Subject: Facility Survey of the White Pine County Courthouse, Ely, Nevada

FACILITY SURVEY

Name of Facility: WHITE PINE COUNTY COURTHOUSE

Date of Survey: September 13, 2007

Shrubbery covering 1st floor windows

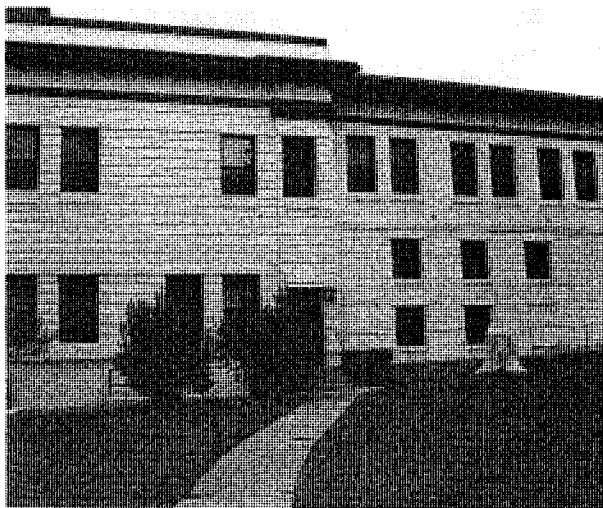
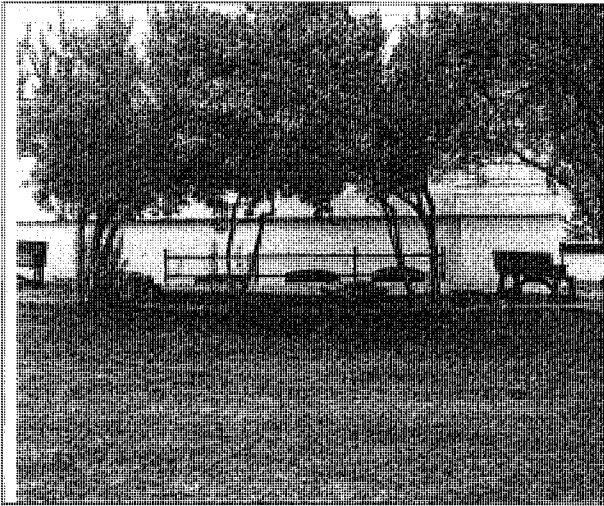
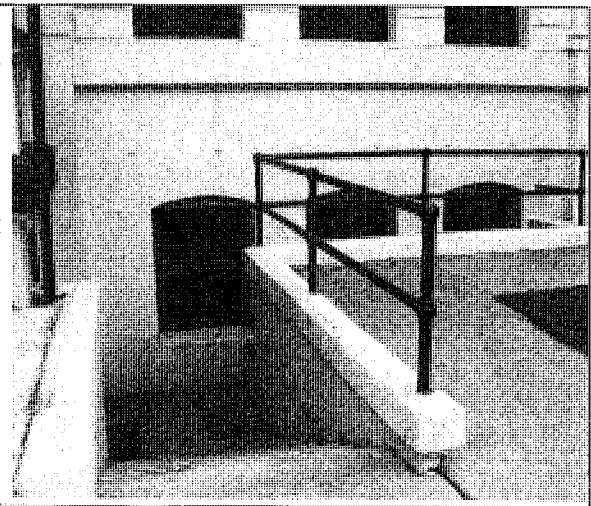
Problem: The exterior lighting is minimal, there is no exterior camera coverage, the courthouse windows lack proper tinting to prevent viewing directly into the offices, the shrubbery is not trimmed properly and the wells leading to the basement windows are not properly secured or monitored.

Shrubbery can easily shield someone so the shrubbery pictured should be trimmed so it is 12" to 18" below the bottom of the window frame. In the 3rd picture shrubbery works to your advantage by blocking the view into the windows without shielding someone at ground level, just make sure the ground level growth remains trimmed at all times.

The basement window wells around this facility are wide open and can easily conceal an intruder. This area should be enclosed and access by hard key or card key ingress only and a push-bar egress for emergency exit. Any intruder will most likely access this area first so this area must be monitored closely through video and proper lighting.

Recommendation: Additional lighting is necessary to properly illuminate 360 degrees around the courthouse with emphasis on all access points, all basement well areas, the grounds within a short distance of the courthouse and the walkways.

Monitored perimeter PTZ high resolution color cameras need to be placed around the courthouse to allow 360 degree coverage of the facility. (PTZ: Pan-Tilt-Zoom).

Window tinting or solar screens are necessary to prevent direct line of site into office windows during the day. Please understand these offer no protection at night, so all offices should keep their interior blinds at an oblique angle at all times.

Campton Street South of Courthouse

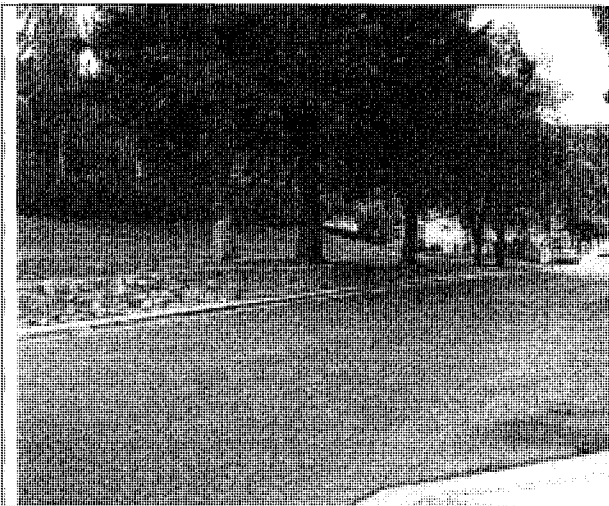
Problem: As you can see in the photos below there is no buffer zone between the facility and Campton Street and cars are allowed to park within close proximity of the courthouse.

Recommendation: This section of Campton Street should be blocked off to prevent normal traffic and parking near the courthouse; the area to the left has an open area which could be converted for additional parking and the wall pictured could be reinforced as a blast wall to protect from anyone parking a car in the lot with lethal intentions.

Gap between prisoner sally port & office

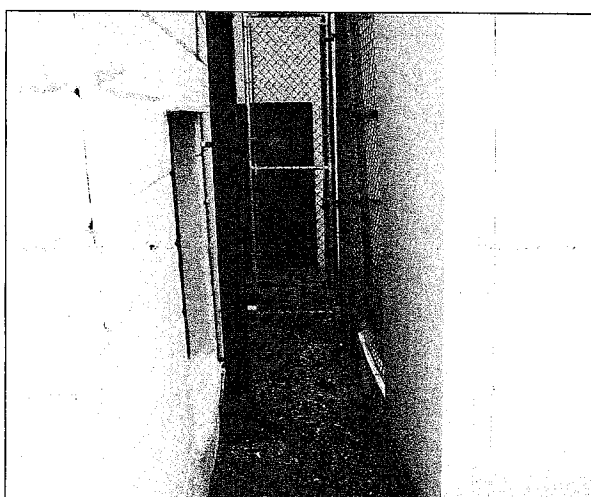
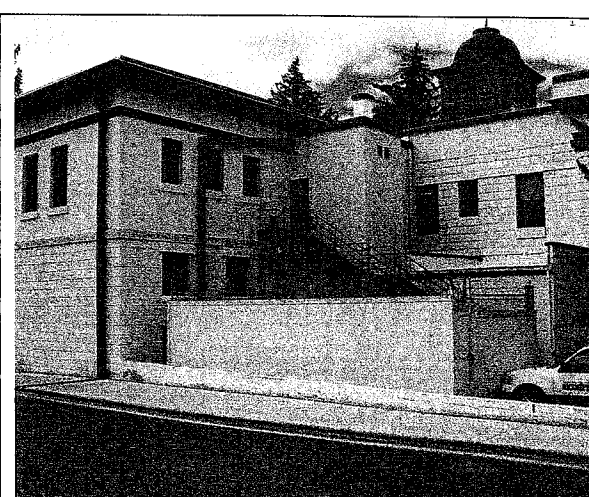
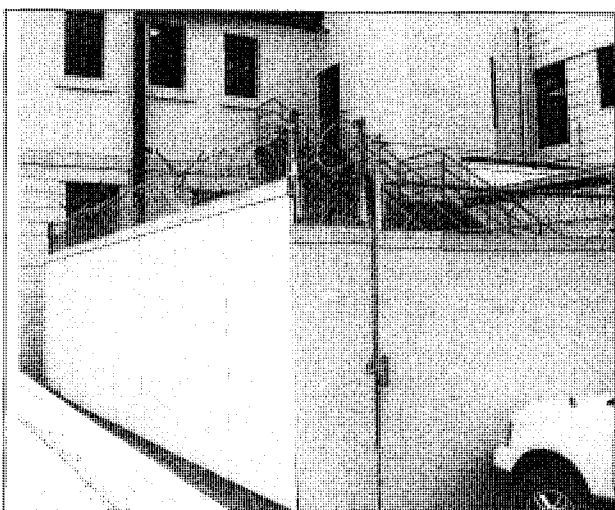
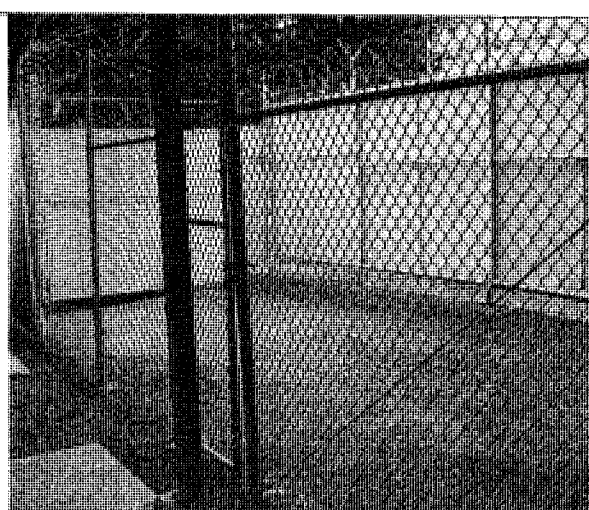
Problem: The first photo shows an open area between the prisoner sally port area and an office window; this area should be sealed to prevent public access and bollards installed to prevent a vehicle from accidentally crashing through the chain link fence and entering the office area.

The other photos show the prisoner sally port which fails to meet minimum security standards. This sally port has no foundation, consists of standard chain link fencing with pad locks and the overhead area is exposed. The exterior prisoner movement area is easily compromised and has no camera coverage or duress alarm in place.

Recommendation: This prisoner sally port should be replaced with a proper and secure facility for prisoner movements. A cement foundation enclosed with secure walls and roof with remote access for the prisoner vehicle rollup gate. The enclosure should also allow direct access to the prisoner ingress/egress courthouse door pictured below. This secure area should have a wall mounted duress alarm and be monitored via a video link. Both the prisoner vehicle roll-up gate and prisoner courthouse door need to be electronically activated from a remote location; transporting officers should never possess keys to either of these doors. An entry control package will be necessary for the monitoring station to have visual and oral communication with those who wish to enter the prisoner sally port area.

Stairs and lower rooftop lead directly to Judicial chambers window

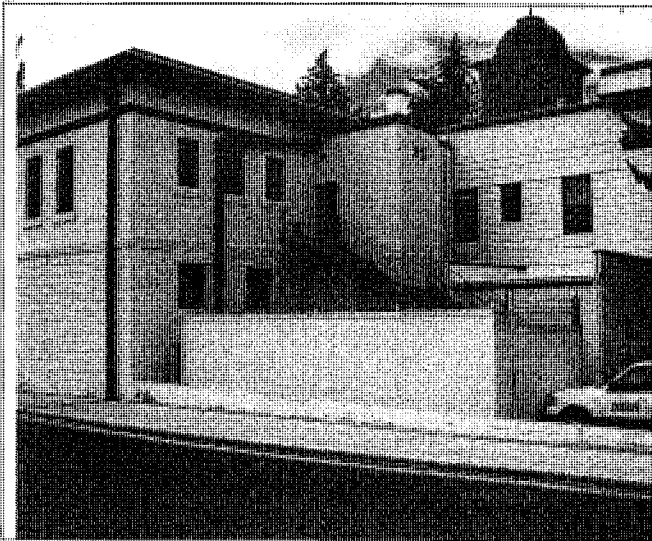
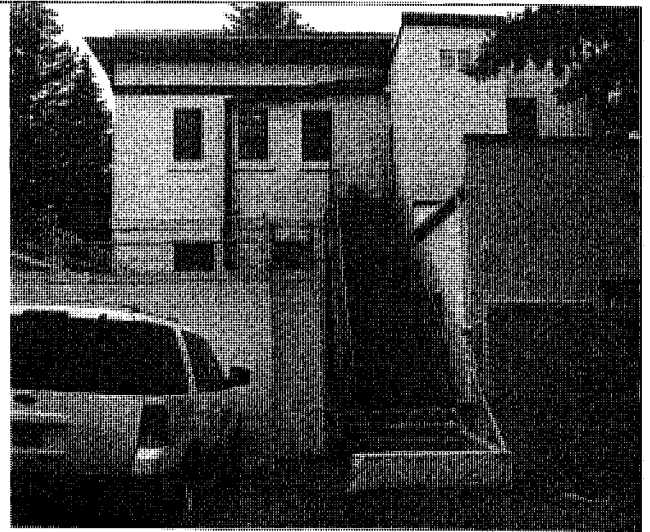
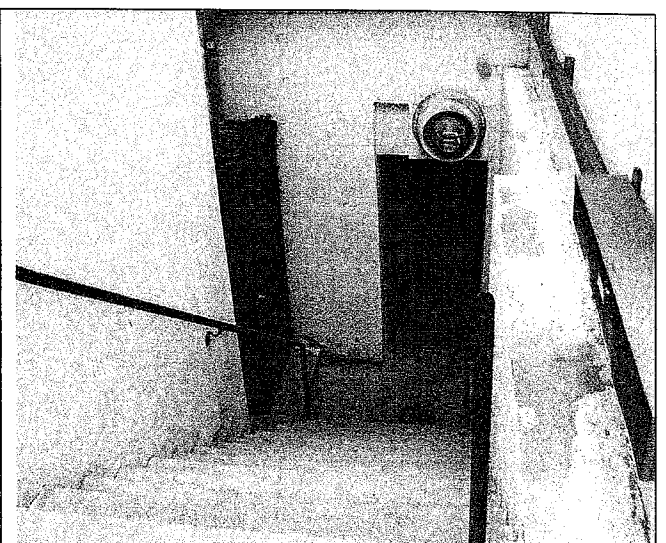
Problem: Open access to the areas pictured below. The gap between the stairs and prisoner sally port is wide enough for personnel to move through allowing access to prisoners and the basement door. The lower roof top leads directly to a judicial chamber window.

Recommendation: This area should be secured and monitored as well to include the grey utility cabinet. Public should not have access to this area and camera monitoring should be dedicated to the small roof top and the exterior basement and 2nd floor doors. The door pictured in the bottom left photo should be encased as part of the prisoner sally port area

North main entrance

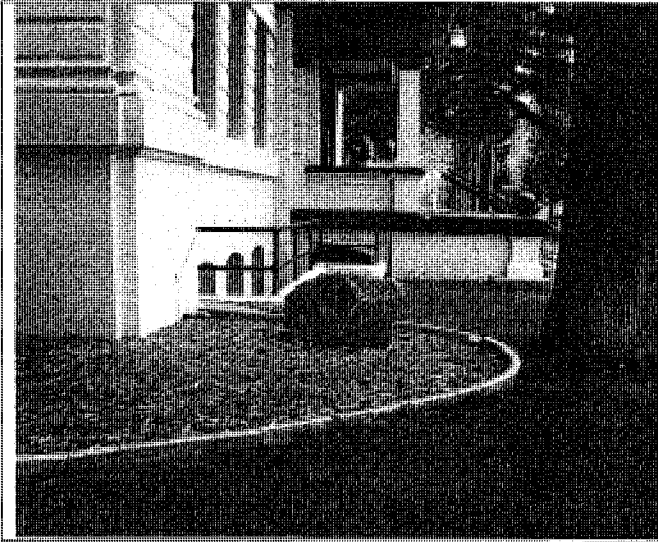
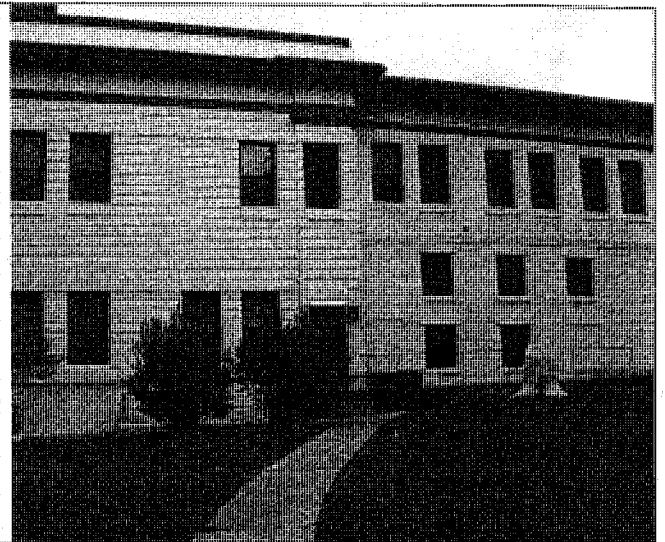
Problem: The entrance offers no protection for this facility or its employees and visitors, nor is it large enough to install security screening devices. Employees are not screened nor is there space to install security screening equipment at the west or south entrances. Also the west entrance does not meet ADA statute requirements.

Recommendation: The front entrance needs be expanded north and widened with a vestibule to accommodate a security screening station and modified to meet ADA statute requirements. Two sets of double doors are necessary, one for ingress and one for egress and another entrance door that meets ADA requirements. Bullet resistant glass panels should be installed to incase the front and side areas of the screening station. The screening station should consist of two magnetometers and at least 1 *Cat Scan machine. The screening station manpower should be no less than two security personnel for light volume and three personnel for high volume times. This allows at least one security officer to observe those approaching and those waiting to be screened while the other two concentrate on properly screening all who enter.

To enhance facility security, a duress alarm and monitor should be located at the screening station to monitor the immediate area outside the vestibule area; which provides timely warning to your first line defenders.

ACCESS POINTS: JUDGES ENTRANCE

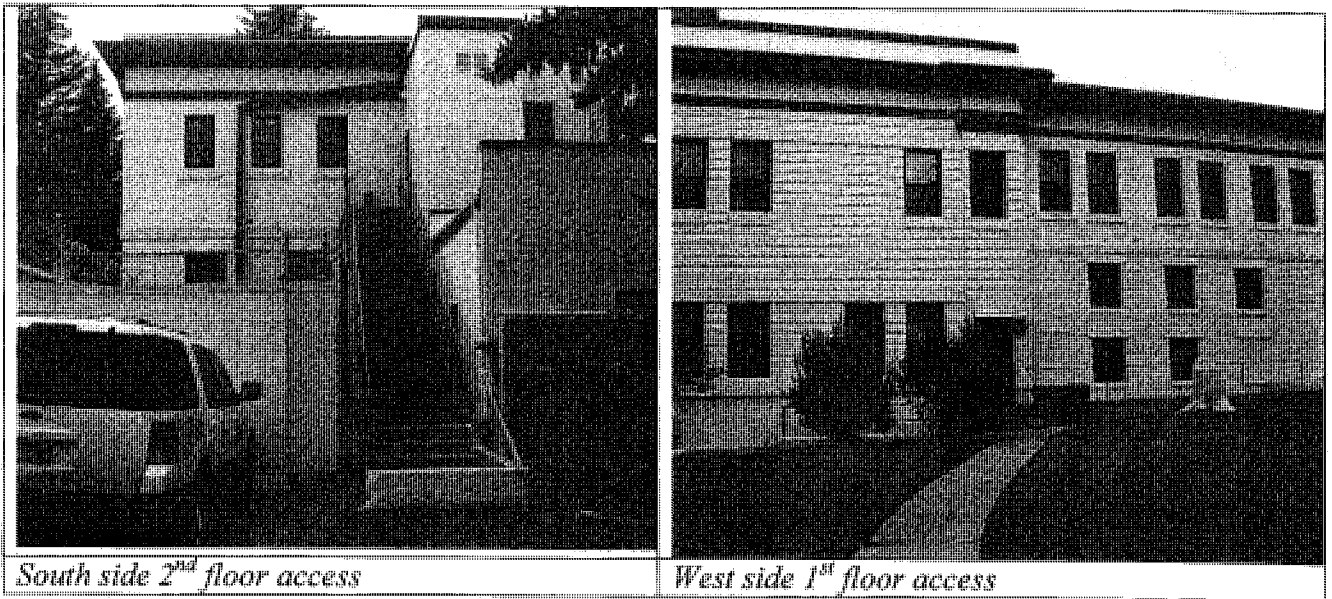
Problem: This area is wide open to the public with no camera coverage and the lighting is below minimum standards for security access points.

Recommendation: The south 2nd floor entrance or west 1st floor entrance should be for judges only and the door they use should be based upon the close proximity of their assigned parking spaces. The judges' entrance should have proper lighting and monitored digital recorded camera coverage.

If the south stairs become the judicial access point this area should be properly secured and monitored with siding along the south railing.

I would recommend when you build a proper prisoner sally port to also encase the stair area to provide judges extra security as they ascend/descend the rear of the building.

Prisoner seating area

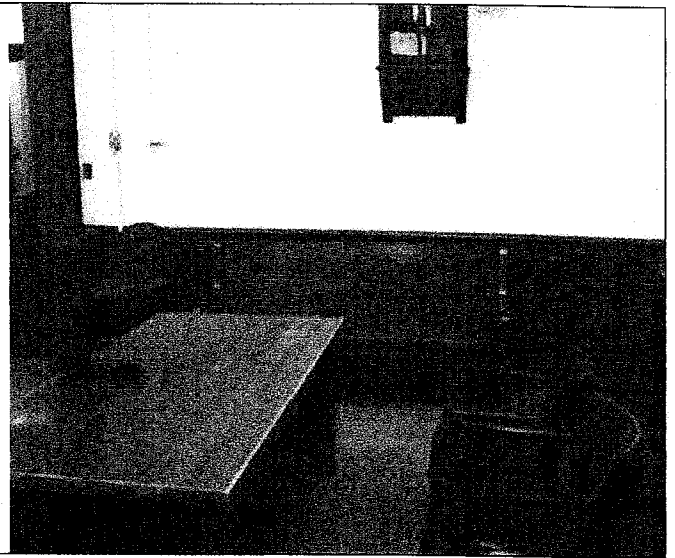
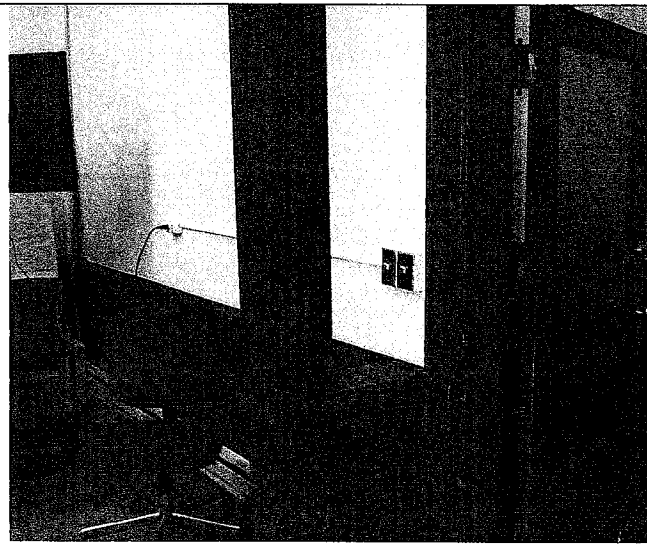
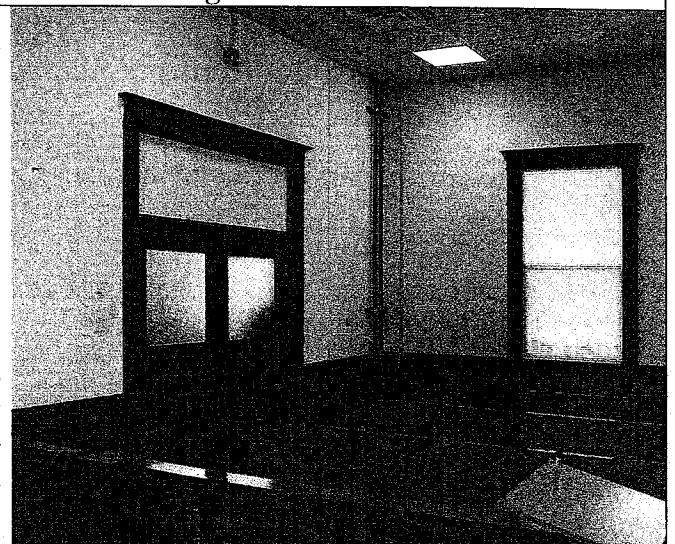
The interior courtroom light switches are accessible and can be easily turned off to create havoc during courtroom proceedings. No security cameras present, no ballistic material is encased in the

judge's bench, windows provide an open view into the courtroom and electrical and plumbing lines are exposed on the outside of the walls.

The prisoner seating location is very antiquated and is not suitable for state maximum security prisoners. This area should be encased since it is positioned so close to the gallery and except for trials all prisoners should remain in full restraints.

The courtroom lighting should be key-controlled to prevent anyone one from manually darkening the courtroom. All exposed electrical and plumbing lines need to be encased in the courtrooms and throughout the courthouse. Exposed plumbing and electrical lines make it to easy to tap into or sabotage for diversionary purposes.

The judicial bench should be lined with ballistic material and there should be two doors allowing emergency egress for the judge. The jury box should be moved further down from the bench and witness stand; the current close proximity does not bode well for courtroom security. The well swing gates should only open towards the bench; if a defendant tries to run they will have to stop and pull the swing gate back to pass through; this momentary hesitation should give court officers an opportunity to react. Courtroom doors should be solid core doors with little or no glass since glass does not mute sounds very well.

COMMON AREA:

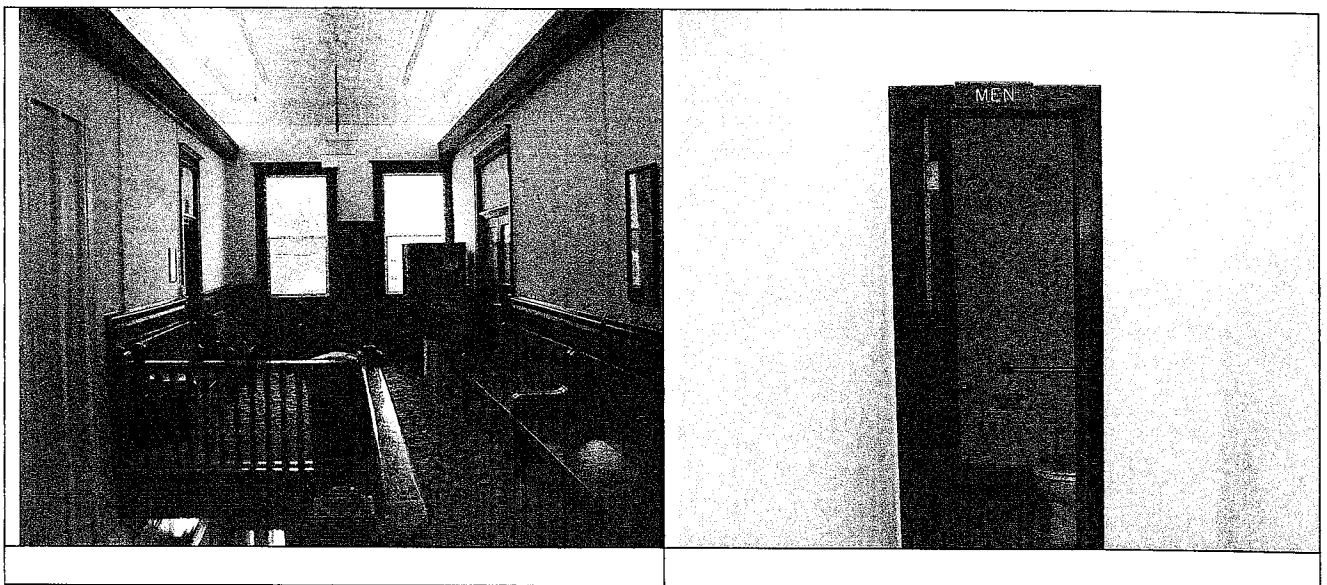
Problem: The common areas pictured below are used by everyone appearing in court. This small area must accommodate jurors, witnesses, attorneys, defendants and their family and friends; prisoners are also escorted past this same area.

The men's room is just down the hall and it is also used by all the above in addition to all prisoners and the judges.

The windows in this area have no coverings and allow direct viewing from the exterior.

Recommendation: If a new facility is not an option I would recommend moving some county offices out of the courthouse so a jury lounge and a public waiting area could be built. I also recommend that restroom facilities be built so the judges and court family personnel are not sharing with the public. The jury lounge should also have it own restrooms so jurors can maintain their distance from the public. The security integrity of our jury system is based on jurors having little or no contact with trial personnel before and during proceedings, which in this case cannot be met and falls below minimum security standards.

The windows should have an exterior coating and the interior should also have coverings to prevent direct line of sight in to the waiting area.

Prisoner holding area

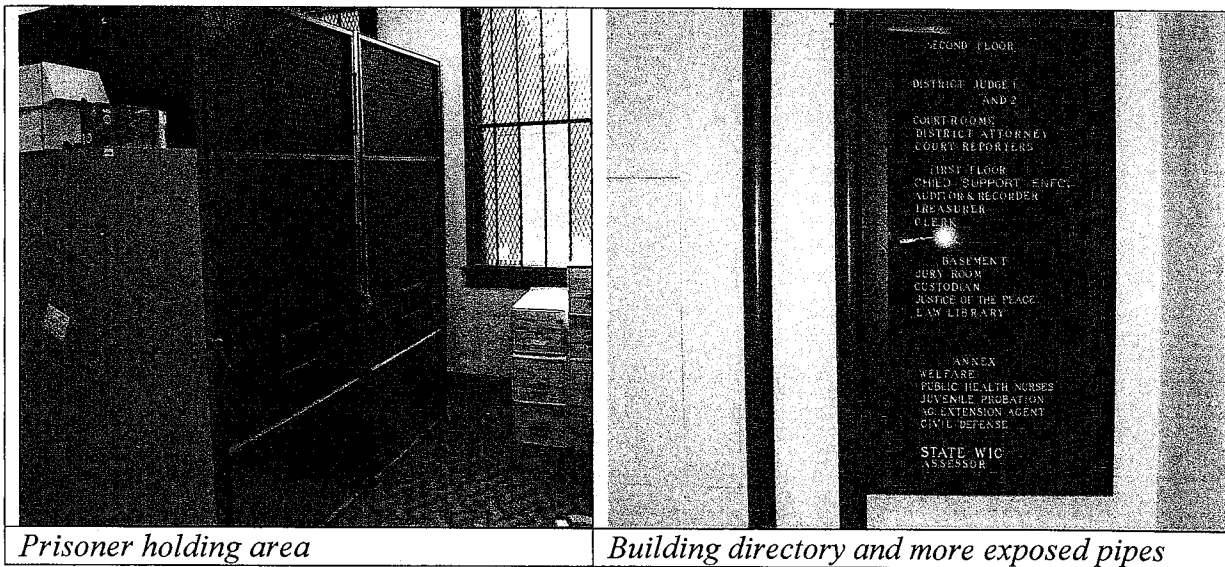
Problem: This facility is not designed or adequately equipped to handle state high security prisoners. Manpower used to handle prisoners in this setting is below minimum standards and poses a direct threat to all court family personnel and visitors.

The building directory is posted in the rear of the building where prisoners wait for the public elevator; this provides them information to the building layout and tenant information. The pipes and electrical lines are a continuing issue throughout the facility.

Recommendation: A major re-model to include prisoner holding cells with proper facilities in place and which also allows direct access into the courtroom without traveling through a public area. A duress alarm should also be installed for law enforcement personnel in the prisoner holding area.

The building directory should be located towards the front of the facility, away from prisoner viewing and the pipes and electrical lines covered to prevent damage by prisoners.

2nd FLOOR: DISTRICT ATTORNEY'S OFFICE:

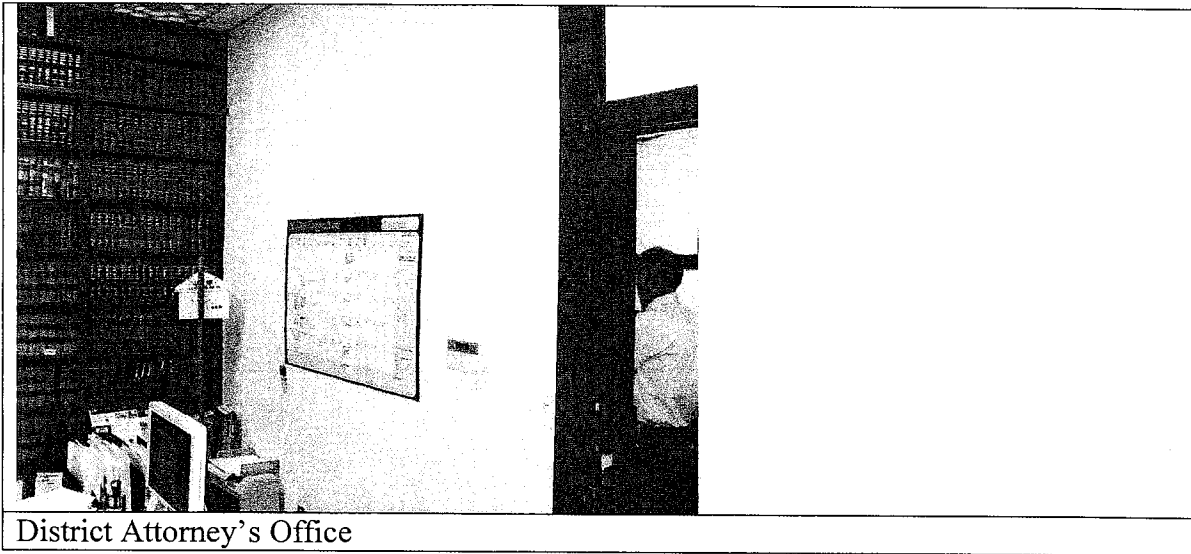
Problem: The DA's Office is open to the public with only one duress alarm in place. There is no emergency lighting and no access control measures in place. This office can handle up to \$2,000 and is kept in a hand carried lock box.

Recommendation: The office door should be a solid core door equipped with a MedCo type lock. The wall pictured with the calendar should be converted to a secure counter top with bullet resistance material and glass. Emergency lighting should be in place and two additional duress alarms installed at the DA and secretary desks. A floor mounted safe should be used to store all monetary items.
